**NJPDES Permit NJ0026671  
Program Interest ID #46322  
Inspection Report & NOV Response**

**Bayway Refinery**  
**January 3, 2020 Compliance Evaluation Inspection (CEI)**  
**Report & December 26, 2019 Notice of Violation (NOV)**  
**NJPDES Storm Water Discharge Permit NJ0026671: Program Interest ID #46322**

**January 3, 2020 CEI Report Deficiency Nos. 1-11**

Figure 1: Tremley Separator and Tremley Ditch

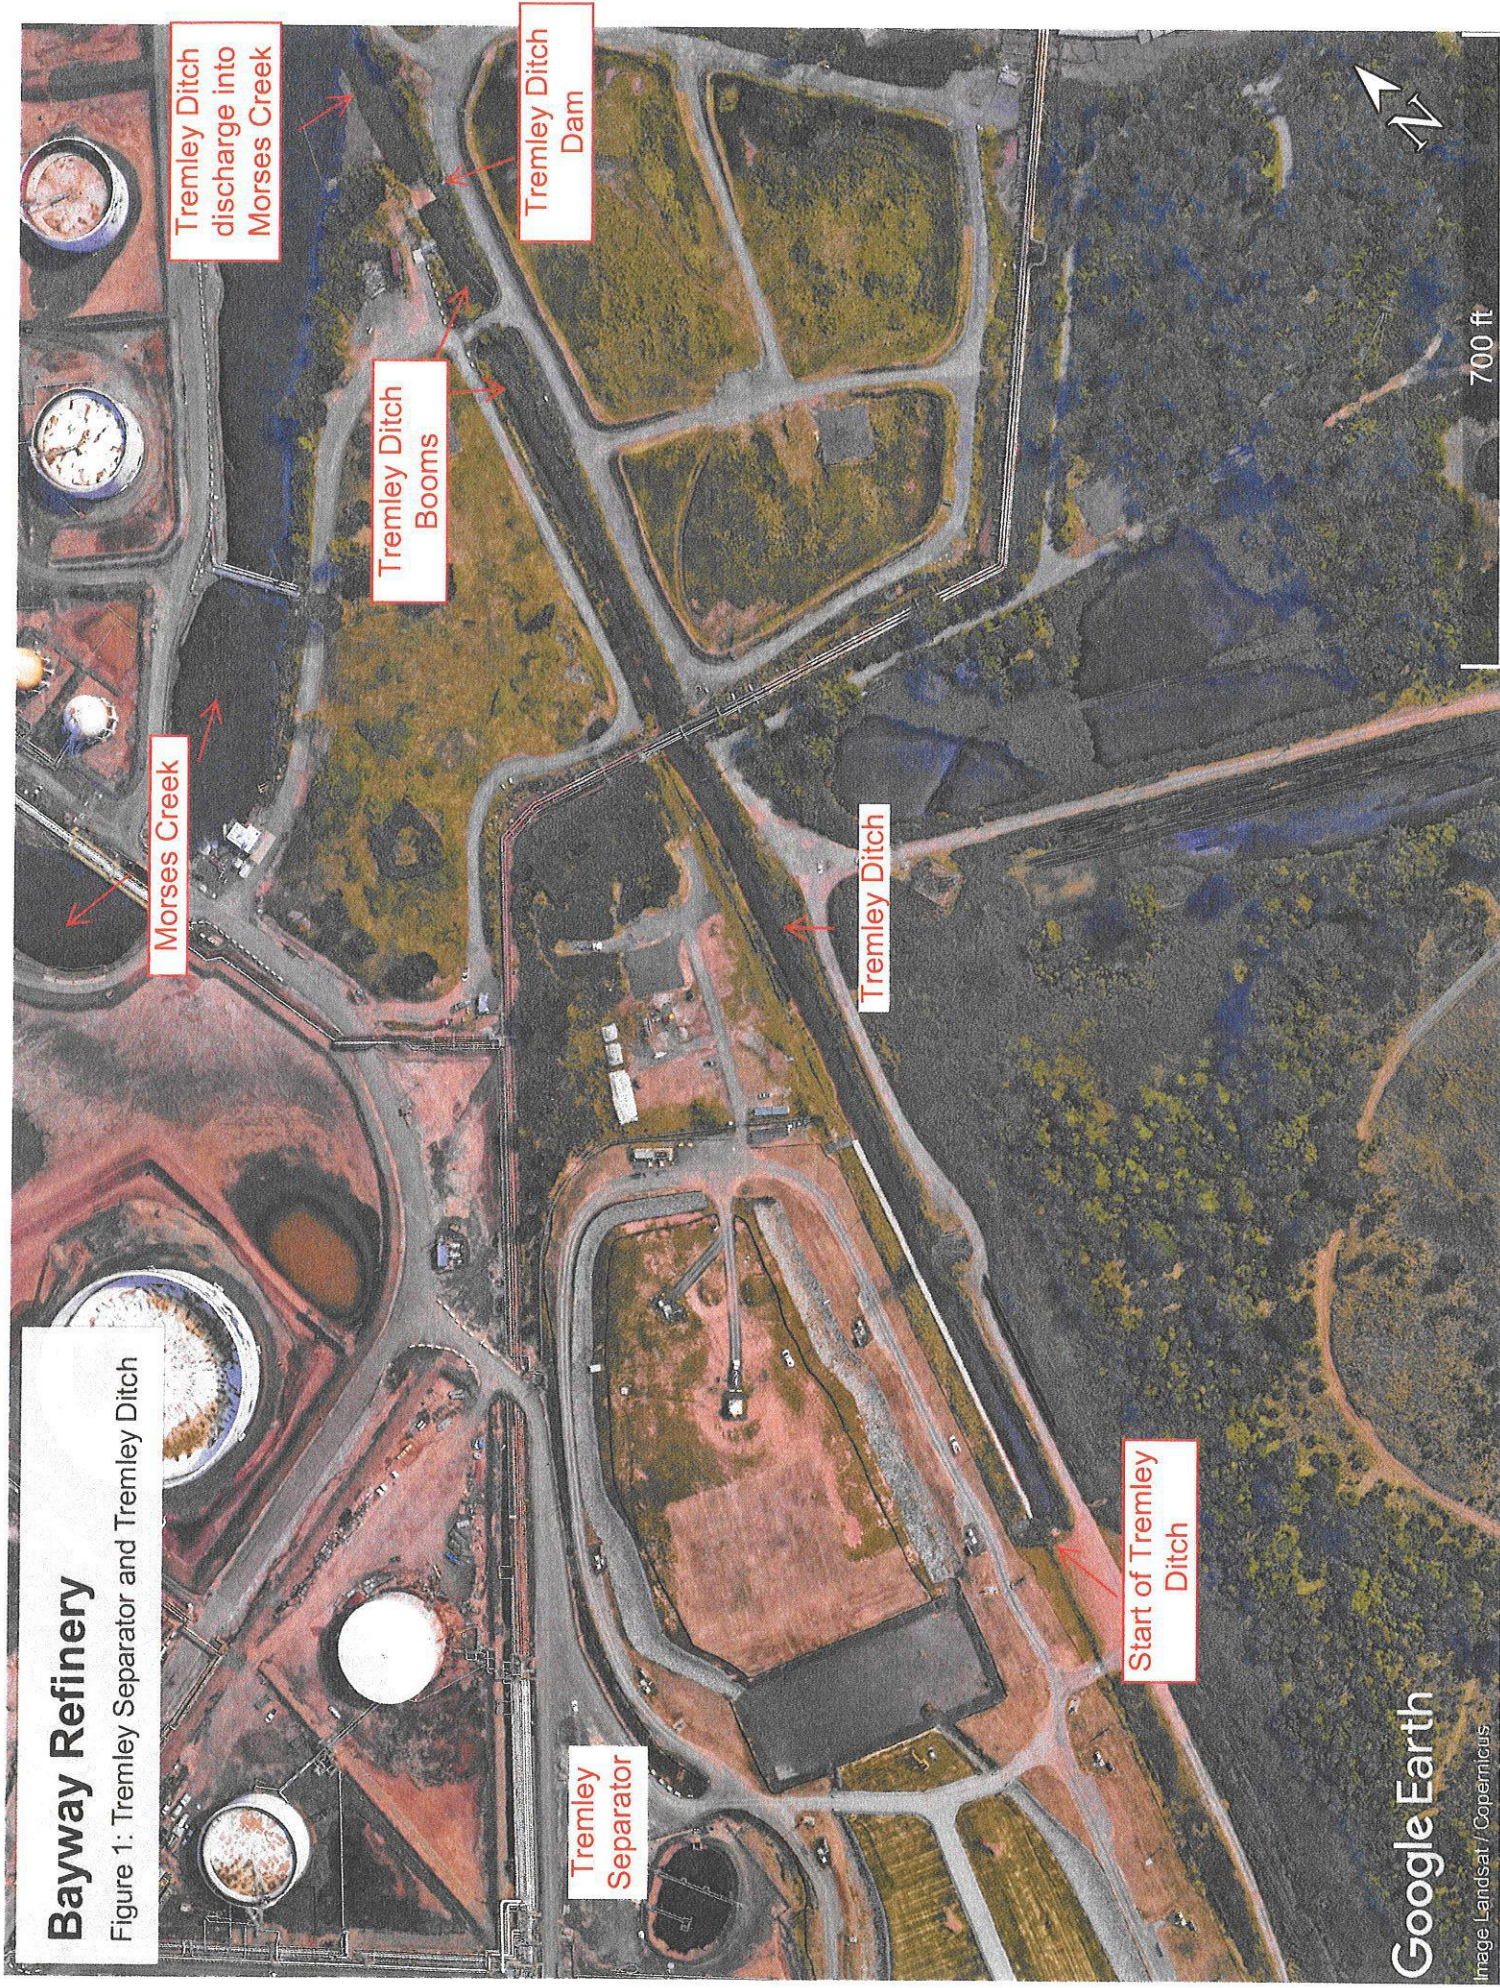
On June 12, free oil was noted on the surface of the stormwater contained in the Tremley Tank Field oil/water separator. The clay lined banks of the separator were stained with oil, as were the many black balls floating within. A petroleum odor was very noticeable. Furthermore, a very visible sheen was observed floating in the outfall chamber, along with an old (black), absorbent pig laden with oil. See the attached photos and NOV.

During the October 29 inspection, an oil sheen was observed on the surface of the DSN 010 separator. Oil was still coating most balls floating within, and still staining the clay walls. However, the amount of free, floating oil was notably less than observed on June 12. According to representatives of P66, this separator is routinely skimmed by vacuor truck. Furthermore, little sheen was noted in the outfall chamber, though historic staining was still observed on the walls.

P66 is hereby REQUIRED to institute the same BMPs for this DSN 010 outfall as the 8 others in your Permit. P66 must continue to remove floating oil, and clean the banks of this separator and effluent chamber. Fresh absorbent pigs should be maintained floating in the final outfall chamber.

The Tremley Separator is an oil-water separator in stormwater service for Tremley tankfield. The separator was constructed in the 1920s and updated in 1964. The separator basin is an earthen surface impoundment constructed of compacted clay covered with stone for erosion protection. The depth from the floor to the top of the berm was 13 feet until the separator berm was raised one more foot in 2001 to be level with connected tank berms (to ensure containment when valves are open). It has an oval shape with a width of 80 feet and a length of 100 feet. The separator basin is covered with floating plastic balls which are maintained in accordance with an air permit requirement to reduce air emissions from Tremley Separator. Flow from the basin passes through two twenty inch diameter pipes with downturned elbows on the upstream side for oil containment into a concrete outlet chamber that is about eight feet by eight feet square in surface area, open at the top. The outlet chamber then has two separate twenty inch diameter outlet pipes that discharge out of the chamber. The outlet pipes originally discharged directly into the beginning of the Tremley Ditch near the Tremley Separator. The initial part of the Tremley Ditch was filled in by ExxonMobil in the 1990s to accommodate a site remediation project. ExxonMobil replaced the initial part of the ditch with a 48 inch diameter sewer that now carries the Tremley Separator discharge through the site remediation project area to the new beginning of the Tremley Ditch, which is now the upstream end of the Tremley Ditch.

Although P66 does not agree that the observation of oil in the Tremley Separator is a violation of the permit, we will implement additional steps to further reduce the risk of an oil release from the Tremley Separator, including the following actions in response to the inspection report deficiencies and recommendations, and NOV:

pH = 7.54 Standard Units  
 TOC = 3.4 mg/l  
 TSS = 14 mg/l  
 TPH =<1.7 mg/l
- Regarding floating oil within the separator basin: Bayway will skim the separator at least twice per week with a vacuum truck when there is a visible floating oil layer. Bayway may apply hot water to the separator to enhance mobility of the floating oil trapped between the balls and improve skimming. Once weather turns warmer and floating oil viscosity decreases (e.g., May), if floating oil is still present, Bayway will attempt to use a drum skimmer in the separator as a trial to see if skimming of oil trapped between the floating balls improves. Skimmers will plug under current conditions and may still need the application of hot water to enhance floating oil skimming during warmer weather depending on the viscosity of the floating oil.

- Regarding sheen in the separator outlet chamber: Bayway will maintain and replace absorbents in the outlet chamber on a weekly schedule as long as sheen is present.

- Regarding stained concrete walls: Bayway will wait for warmer weather (e.g., May) before trying to hot water wash the stained areas. Pressure jetting is not recommended because of the age and unknown condition of the concrete. Any staining that does not come off with hot water washing in warm weather will be considered to be immobile, contained and as presenting no environmental impact risk.

- Regarding stained earthen/stoned banks: Bayway will wait for warmer weather (e.g., May) before applying hot water over the stained areas. Pressure jetting should not be used as it will erode the stone and clay unnecessarily. Any staining that does not come
